Subject: Issuance of Amendment No. 42 to Facility Operating License NPF-35 and Amendment No. 35 to Facility Operating License NPF-52-Catawba Nuclear Station, Units 1 and 2 (TACS 67115/67116)

AMENDMENT NO. 35 TO FACILITY OPERATING LICENSE NPF-52 - Catawba Nuclear Station, Unit 2
AMENDMENT NO. 42 TO FACILITY OPERATING LICENSE NPF-35 - Catawba Nuclear Station, Unit 1

SAFETY EVALUATION BY THE OFFICE OF NUCLEAR REACTOR REGULATION
RELATED TO AMENDMENT NO. 42 TO FACILITY OPERATING LICENSE NPF-35
AND AMENDMENT NO. 35 TO FACILITY OPERATING LICENSE NPF-52

CATAWBA NUCLEAR STATION, UNITS 1 and 2

FIGURE 3.2-3
REACTOR COOLANT SYSTEM TOTAL FLOW RATE VERSUS R - FOUR LOOPS IN OPERATION

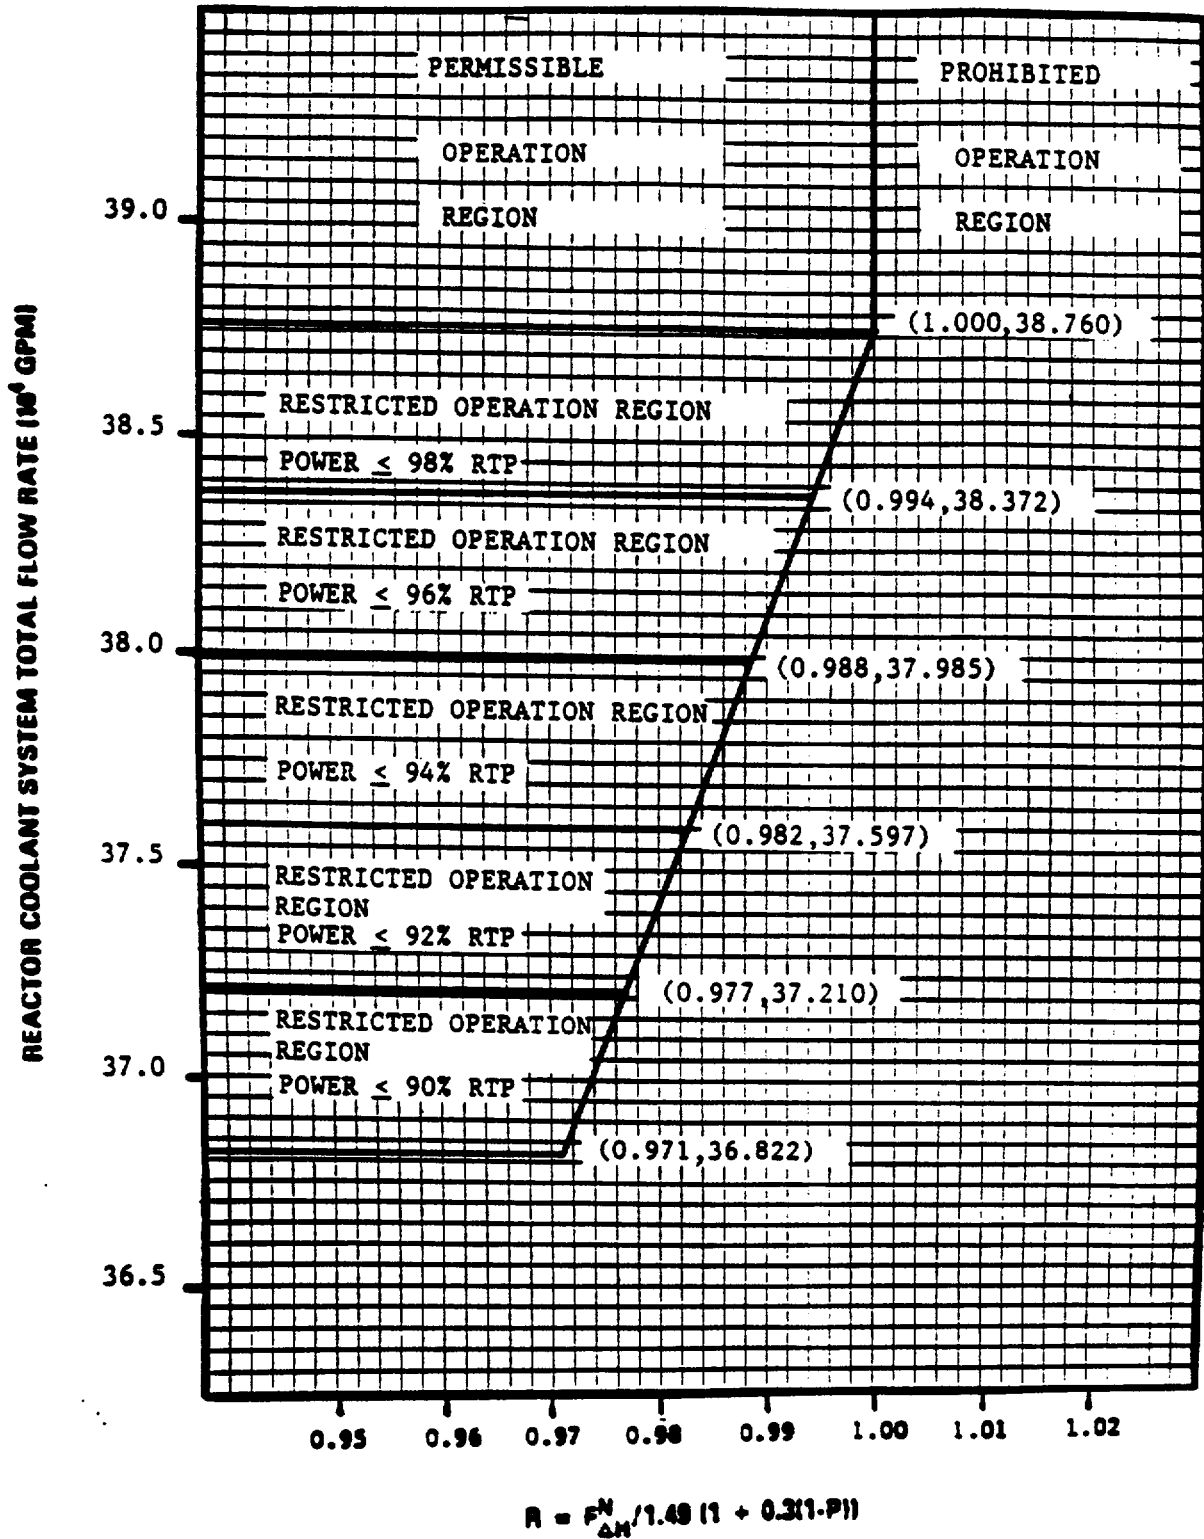
- a. With the combination of Reactor Coolant System total flow rate and R within the region of restricted operation (flow rate less than 387,600 gpm), within 6 hours reduce the Power Range Neutron Flux-High Trip Setpoint to below the nominal setpoint by the same amount (% RTP) as the power reduction required by Figure 3.2-3.

By letter dated February 10, 1988, Duke Power Company, et al., (the licensee) proposed amendments to the operating licenses for Catawba Nuclear Station, Units 1 and 2, which would change Technical Specification (TS) Table 2.2-1, TS 3/4.2.3, and TS Figure 3.2-3 to reduce the required Reactor Coolant System (RCS) total flow from 396,100 gpm to 387,600 gpm.

minimum measured flow, 387,600 gpm, adjusted down by the flow uncertainty, 2.2%, to give 379,073 gpm. All of these transients are currently analyzed, as outlined in the above submittal, with flow rates less than this adjusted value and are therefore conservative.

The thermal hydraulic design analyses for the latest reload cores, Catawba 1 Cycle 3 and Catawba 2 Cycle 2, used the minimum measured flow of 387,600 gpm. It can be seen from this and from the preceding discussion of FSAR Chapter 15 analyses, that all applicable steady-state and transient core thermal-hydraulic analyses have been performed with flows equal to, or conservative with respect to, the proposed TS minimum measured flow.

On the basis of its review, the staff finds that the revision to the TSs will not adversely impact the accident analyses documented in Sections 6.2.1 and 15 of the FSAR nor the steady-state thermal-hydraulic reload design analyses discussed in Section 4.4 of the FSAR. Therefore, the changes to TS Table 2.2-1, TS 3/4.2.3, and TS Figure 3.2-3 are acceptable.
